Subject: Auditorium visit findings and recommendations
Farmington High School
Farmington, CT
Acentech Project No. 623329

We visited Farmington High School on April 23, 2013 to measure the acoustical conditions of the Auditorium and to discuss the goals for the Auditorium renovation with you and Farmington HS staff. This letter summarizes our findings and recommendations for improving the acoustics of the Auditorium.

Figure 1: Auditorium sidewalls, "boxed in" to square the sides, including an angled reflector at the bottom.

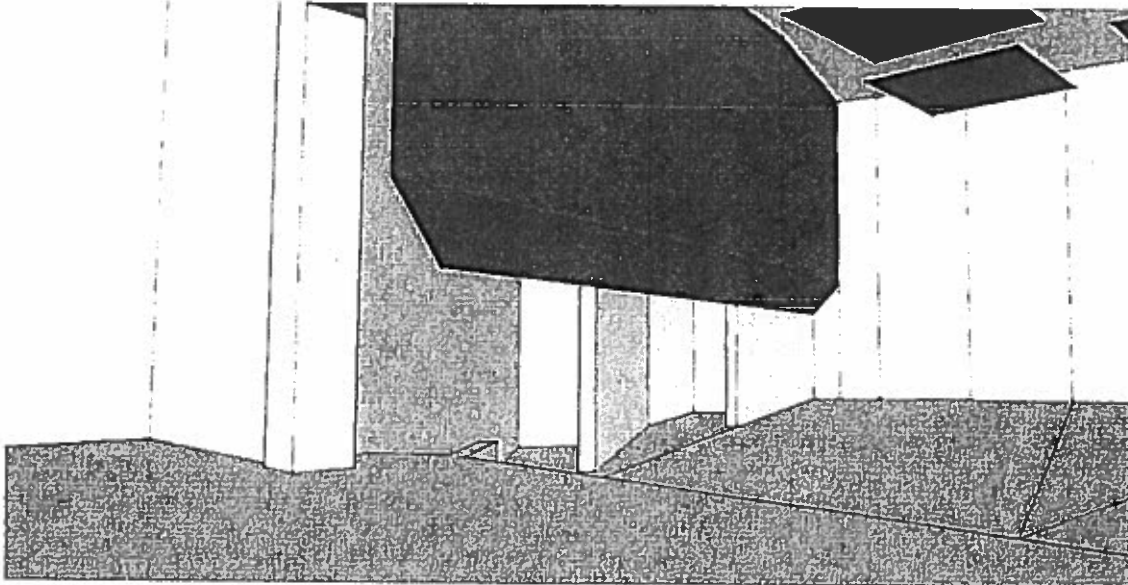
- **Add absorption to the rear wall.** Some additional absorption will be needed to balance the room if the ACT ceiling is removed. We recommend treating 2500 sq.ft. of the rear wall if the sidewall curtains are included. If sidewall curtains are not included, we recommend 1500 sq.ft. of absorption be added to the sidewalls above audience height. The recommended treatment material is 2" thick glass fiber panel with an NRC of 1.00. The final amount of treatment should be decided when the design is more developed.
- **Box in the fanned sidewalls, with an angled bottom to reflect sound to the seats.** This will bring the overall geometry of the hall closer to the preferred "shoebox" shape. An angled bottom will provide side reflections without having to redesign the current doors. (See Figure 1.)

Figure 2: Farmington Auditorium, current structure to be removed in Blue.

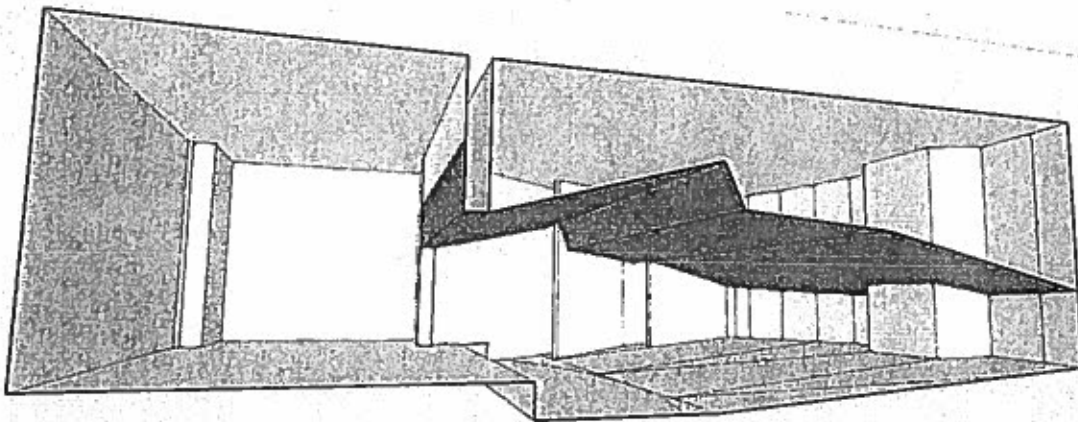
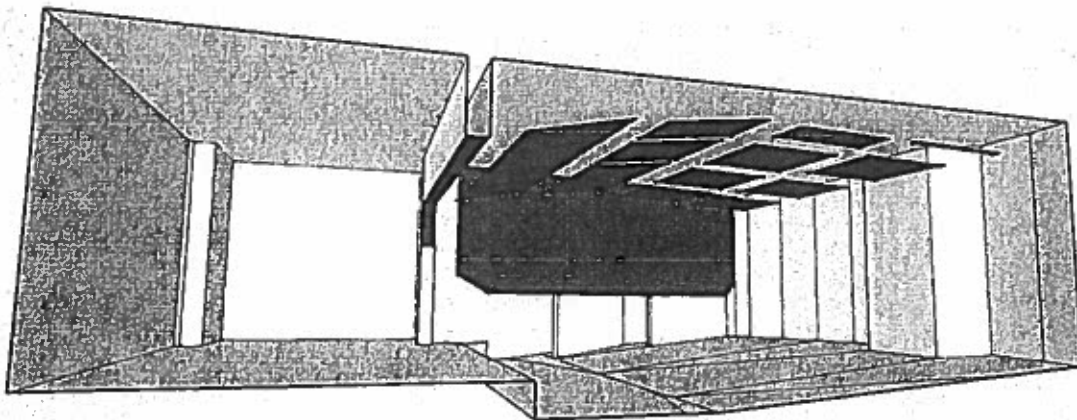
- **Remove the current ACT ceiling, and replace it with hard reflectors.** This will greatly increase the volume of the hall and remove a large amount of absorption, both of which will increase the reverberation time. The hard reflectors will allow ceiling reflections to supplement the weak sidewall reflections. Reflectors are available in

- **Raise the edge of the proscenium.** Opening up the proscenium will allow more sound out into the hall; curtains can then be used to create a visual break at whatever height is desired. The opening should be at least 24 ft. tall.
- **Add retractable curtains in front of the sidewall boxes.** Curtains that can be extended to cover as much of the sidewalls above standing height as possible will allow for a substantial variability in reverberation time. Ideally, these will extend from the upper edge of the box's angled reflector to the deck and cover approximately 2500 sq.ft. of the sidewalls.
- **Upgrade the stage shell.** A more substantial stage shell, ideally with a ceiling, will allow sound to fully project into the hall. A shell similar to the Wenger *Forte* series would be ideal. A shell similar to Wenger's *Legacy* series would be a lower-cost option.

The current and suggested designs can be seen in Figures 2 and 3. Additionally, we have attached the SketchUp model used to illustrate these design recommendations. The current structure to remain is on "Layer0", with current structure to be removed on the layer "CurrentCeiling", and the suggested additional structure on the layer "SuggestedAdditions".
